### REMARKS

In the Office Action, the drawings were objected to under 37 CFR 1.84(h)(3) and 37 CFR 1.83(a). Claims 1 and 41 were objected to. Claims 13-19, 27-33 and 43-44 were rejected under 35 USC §112, first paragraph. Claims 1, 6-7, 10-12, 21, 26-33, 35-37, 42-44 were rejected under 35 USC §112, second paragraph. Claims 1, 6-7, 11-12, 21 and 26 were rejected under 35 USC §102(b) as being anticipated by Smith. Claims 1, 6-7, 11-12, 21 and 26 were rejected under 35 USC §102(e) as being anticipated by Yang. Claims 1, 7, 10, 13, 16, 18-19, 21, 26-30, 33, 42-44 were rejected under 35 USC §102(b) as being anticipated by Gustafson. Claims 36-37 were rejected as being unpatentable over Smith and further in view of Abert. Claims 14-15, 31-32 and 35 were indicated to be allowable if rewritten to overcome the rejection under 35 USC §112, first and second paragraphs.

Fig. 1

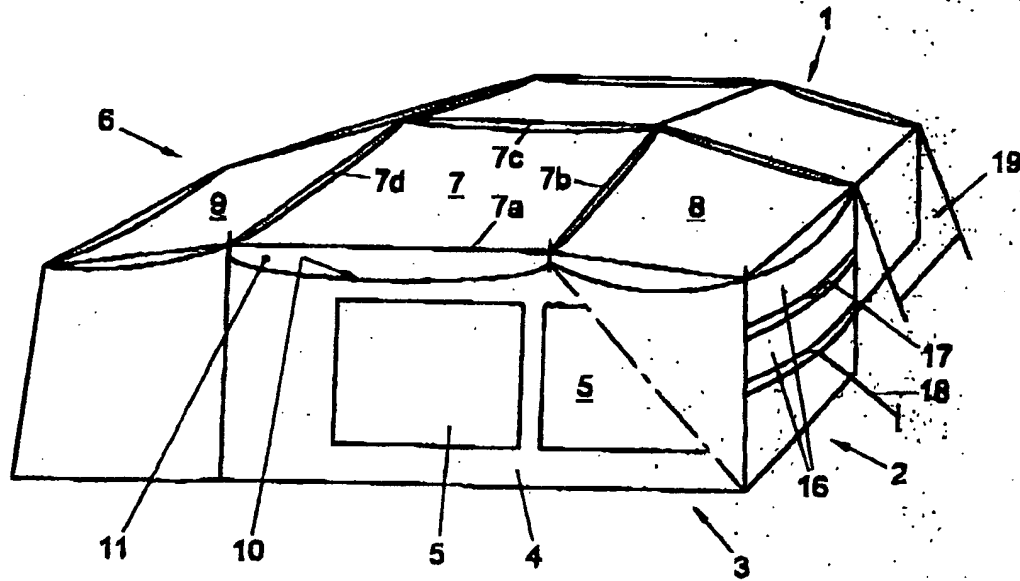
The feature of "detachable mounting a covering panel... so that it is at least partially detachable..." is shown in Fig. 1, because covering panels 16 are shown which can be pulled away from the supporting fabric of the basic panel by means of "expanders" 17 or guy ropes. Please refer to page 11, from line 11, of the specification. Further, Fig. 1 shows roof panel 7 with zippers or the like at 7a-7d along its edges, so that panel 7 is removable. Please refer to page 7, lines 4-10 of the specification. In addition, claim 1 has been amended to remove "detachably" mounting.

Still further, Fig. 1 at 19 shows a wall panel which is "stretched out". What is shown is that the covering panel 19 may be detached from the basic tent except (in this example) along its upper edge, in order to be able to swing the panel outward and fix it in that position by guy ropes or the like.

A covering panel (panel 7 in Fig. 1) is shown which is completely removable, and also for a double walled design having an outer panel (7) and an inner panel (10). The hollow appearance is

obtained by a specific way of cutting the panel which is known in the art and is clearly shown in Fig. 1 and Fig. 3.

Fig. 2

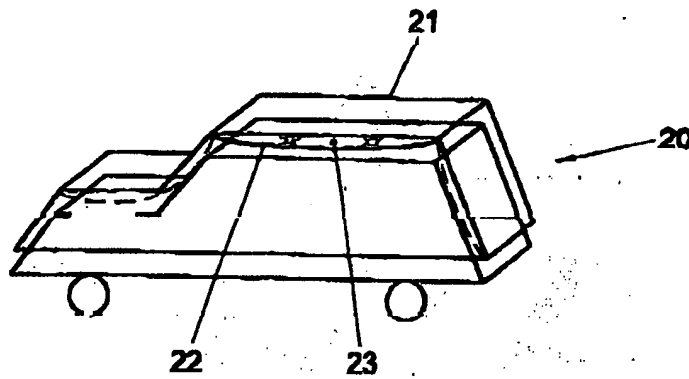
Figure 4 is not a sectional view, but as described in the Amendment filed October 28, 2003, is a detail of a spacer placed between waterproof material 21 and breathing material 22 as shown in Figure 2. A proposed correction to Fig. 2 is attached which includes two spacers in their described location.

As regards the gap, this is shown at 11 both in Fig. 1 and Fig. 3 and also in Fig. 2 in its amended form. Fig. 2 even now shows the spacers maintaining the gap.

Fig. 3

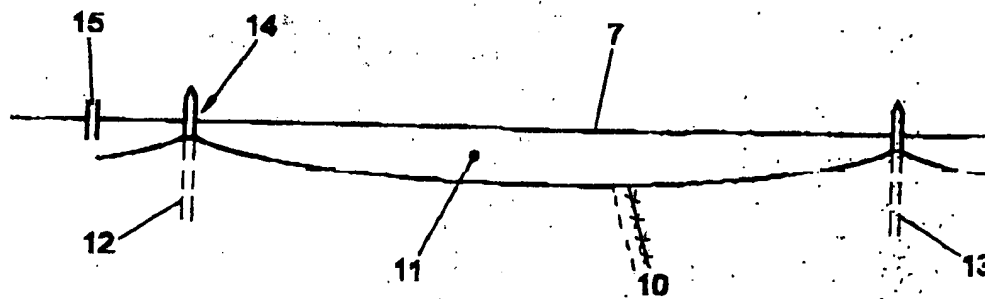
The different material feature is disclosed in the specification. Line 10 in Fig. 3 (representing inner roof panel 10) has been replaced by a dotted line to avoid this informality.
